Macquarie Point Multipurpose Stadium Project of State Significance

Landscape Architecture Evidence

Prepared by:
Barry Murphy
Murphy Landscape Consultancy

July, 2025

Reflectivity & transparency represented by
Orbit Solutions (extract from KOP 03 montage, above and below)

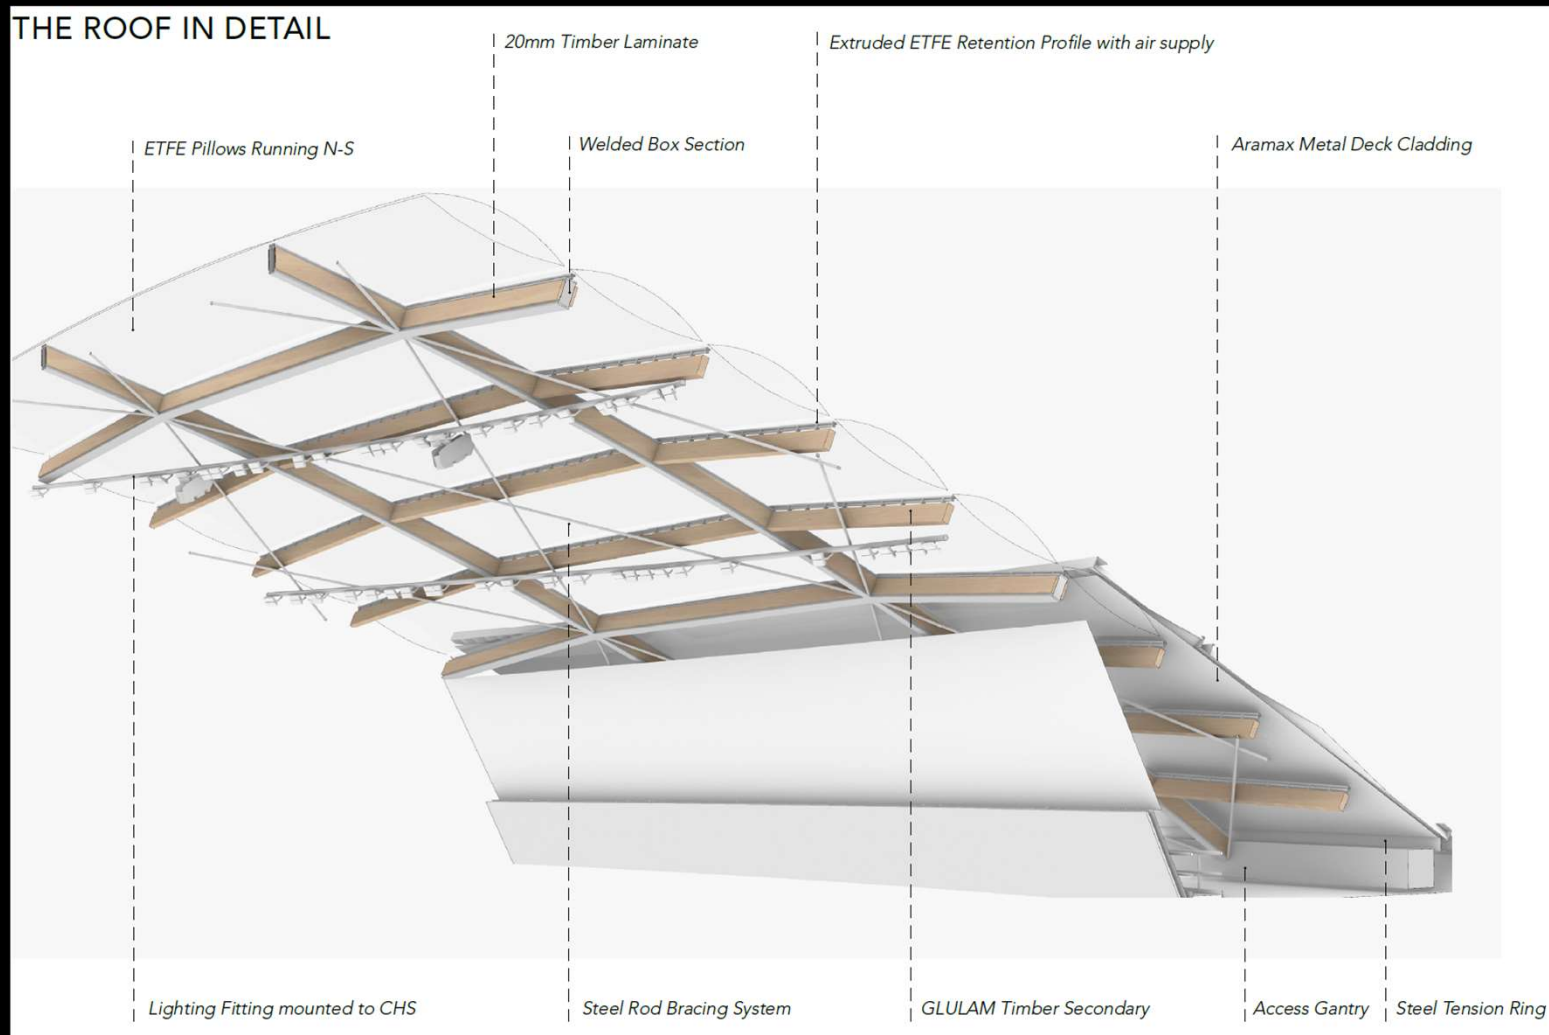
Reflectivity & transparency represented by
Cox Architecture (cover page of TPC presentation)

Section through Northern Stand and the Goods Shed

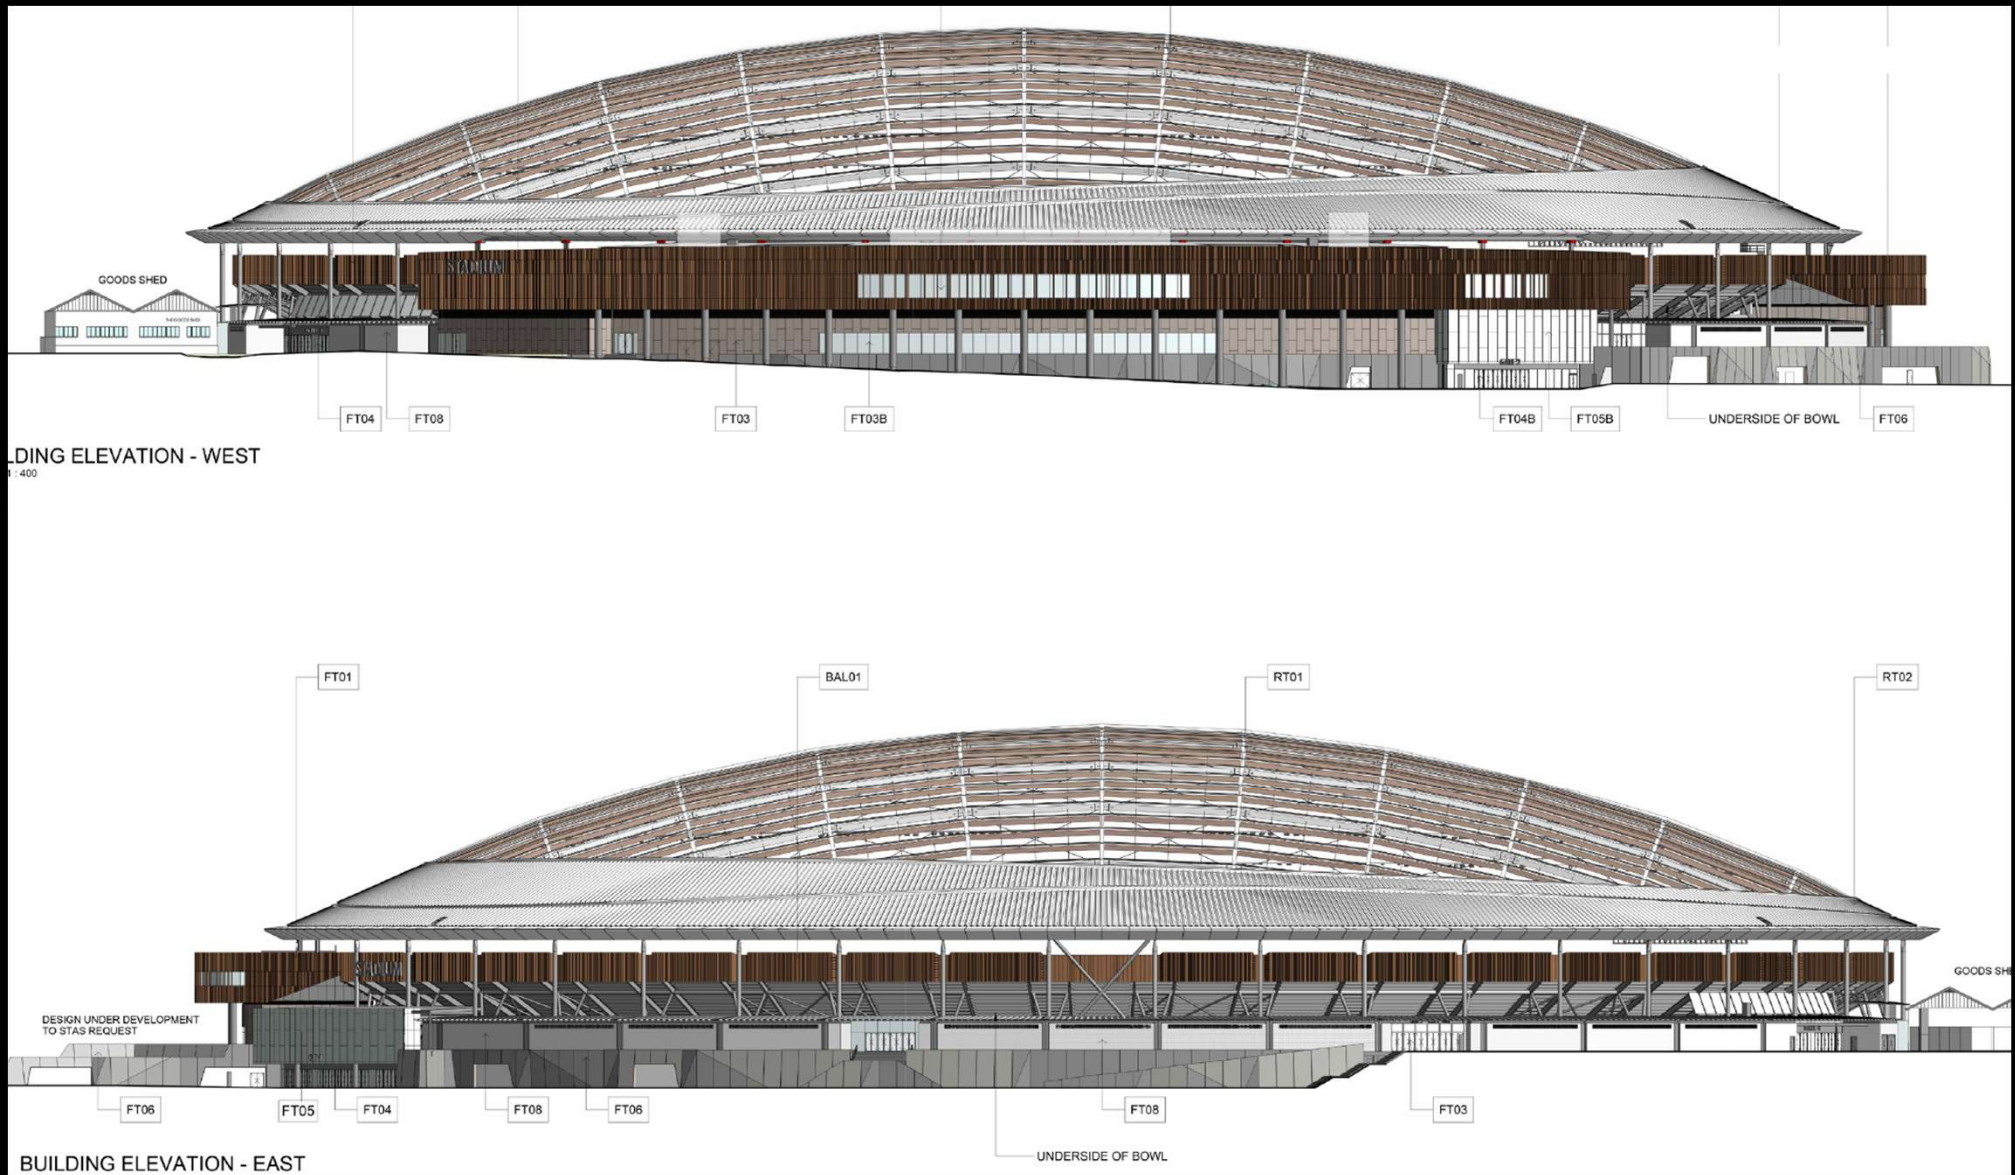
Roof structure – beam density

KOP 04

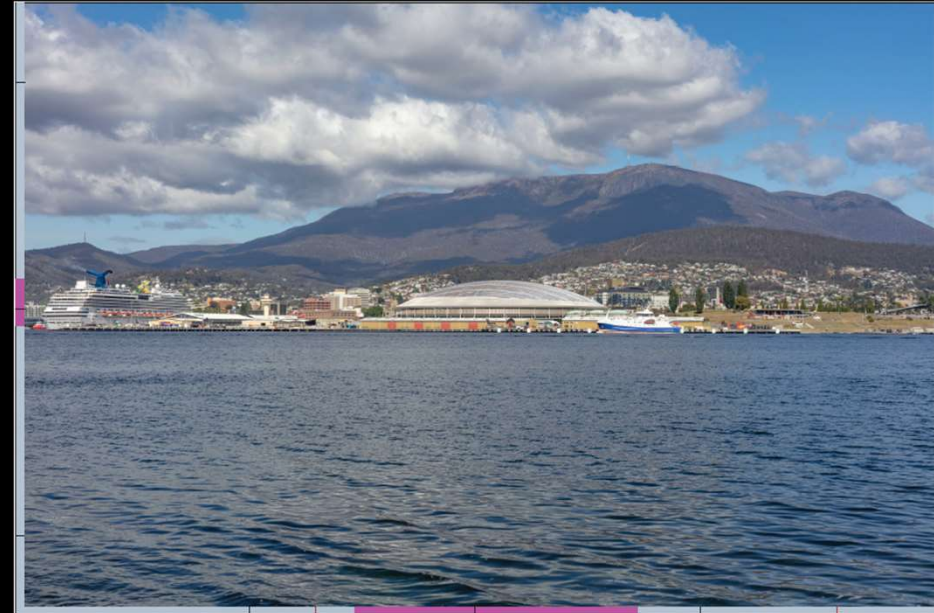
ETFE roof with little or no reflectivity

KOP 10 - Mawson Place – 20mm focal length

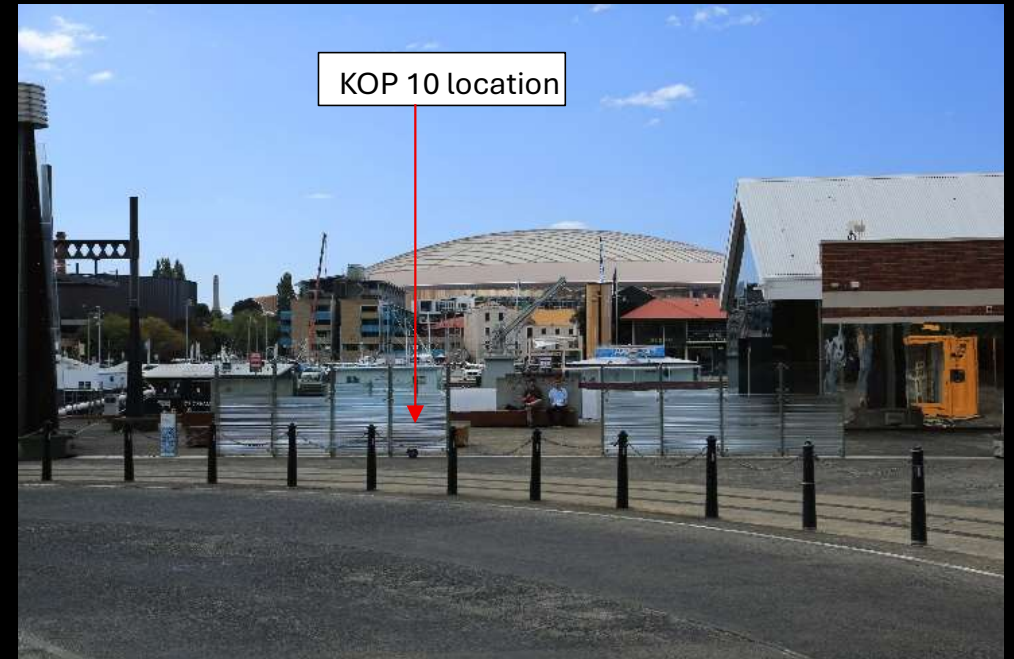
Morrison St, approx. 25m SW of KOP 10 – 50mm focal length

“The 50mm lens is an industry standard for LVIA photography as it is considered to be the closest representation of the human field of view and is widely accepted as the standard focal length when providing expert evidence in court.” (SLR VIA Report, page 25.)

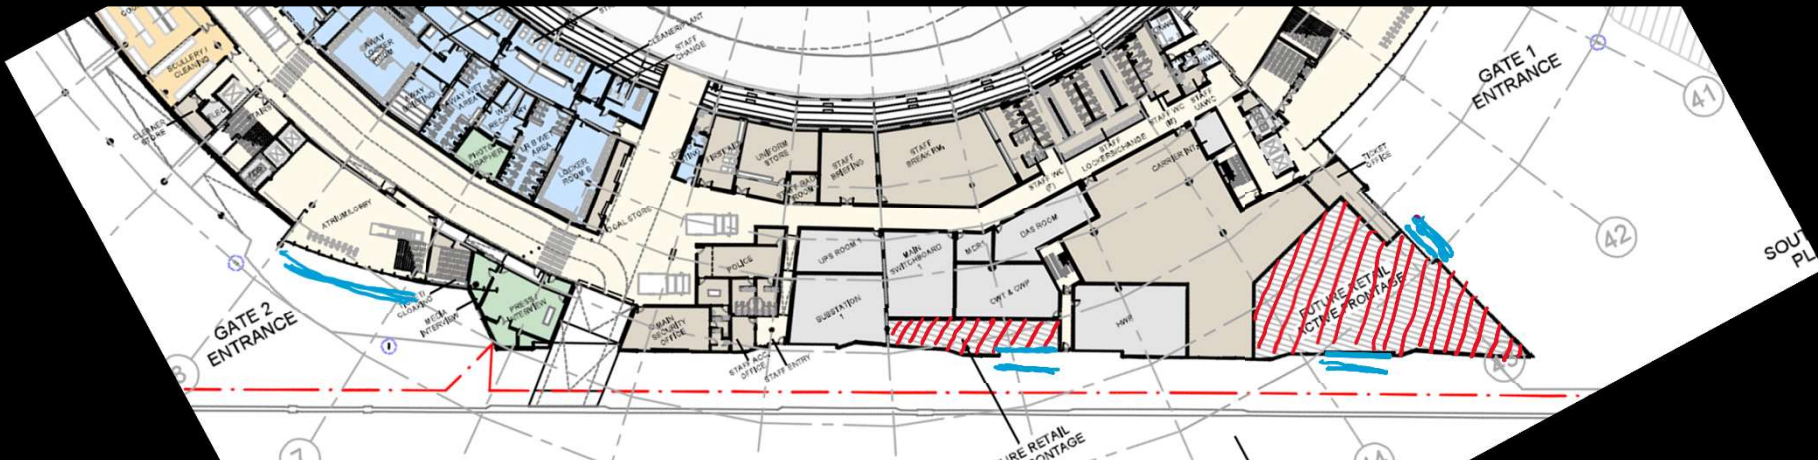
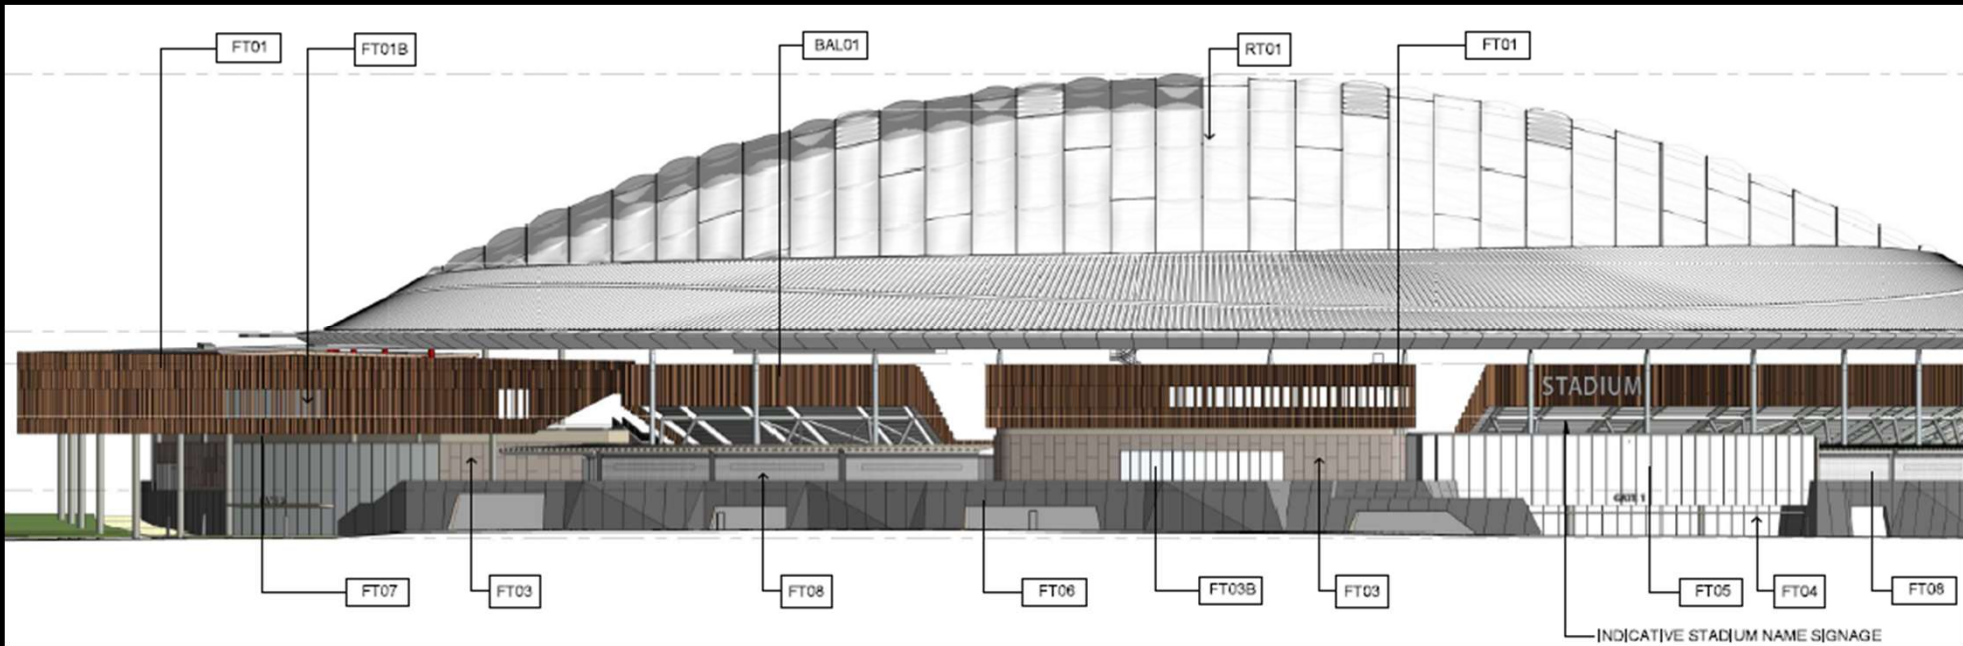
Contrary descriptions:

“activated built wall edge to Evans Street”;

“an airy, verdant embrace around the stadium”;

“careful articulation of lower levels”;

“varied façade treatments at pedestrian eye-level”.

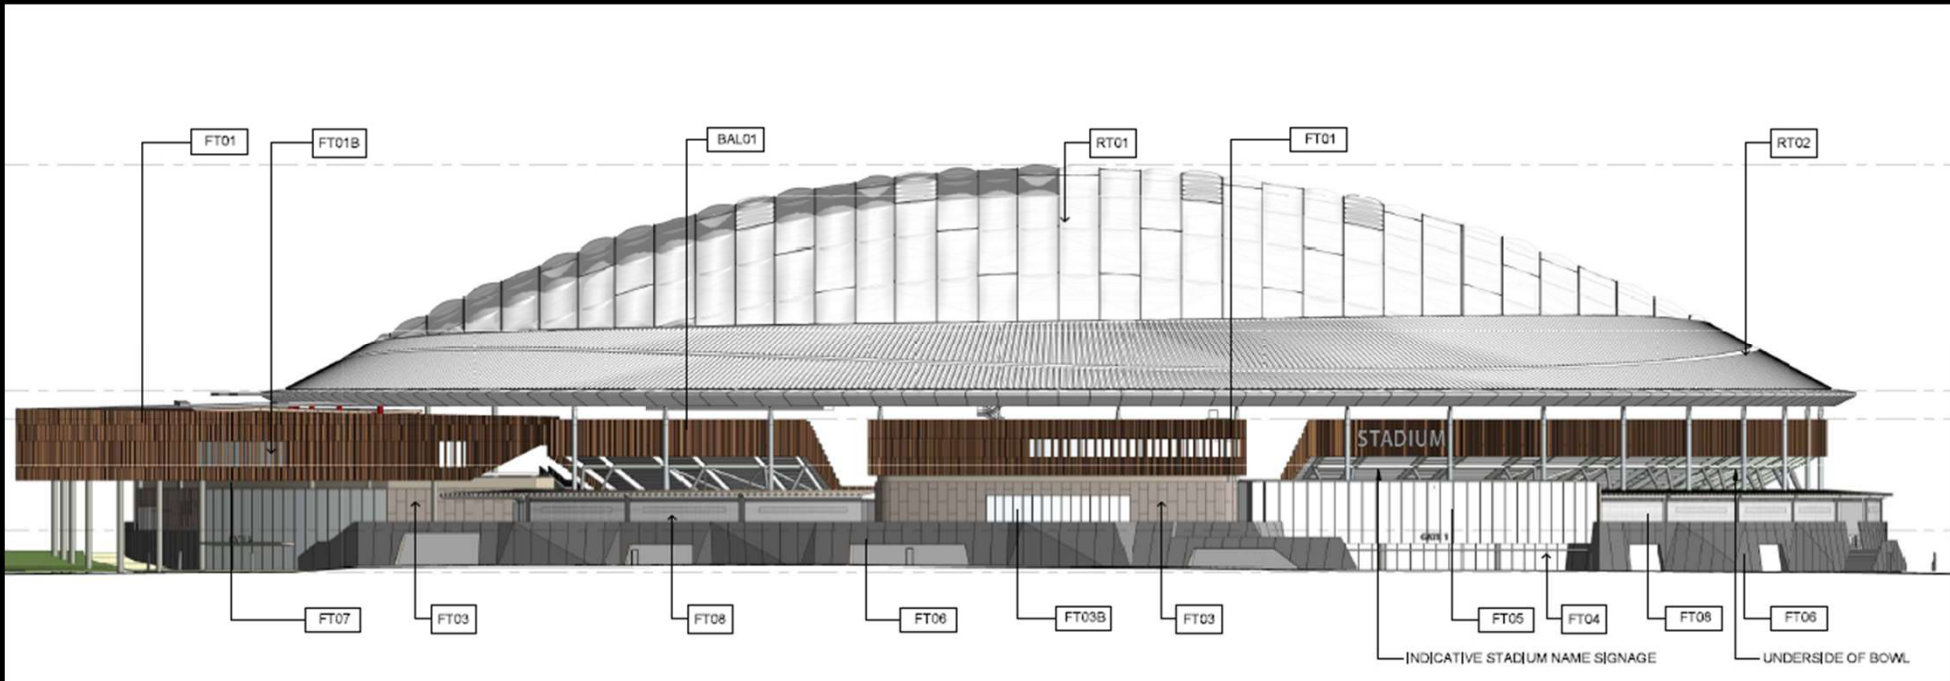
Contrary descriptions:

“activated built wall edge to Evans Street”;

“an airy, verdant embrace around the stadium”;

“careful articulation of lower levels”;

“varied façade treatments at pedestrian eye-level”.
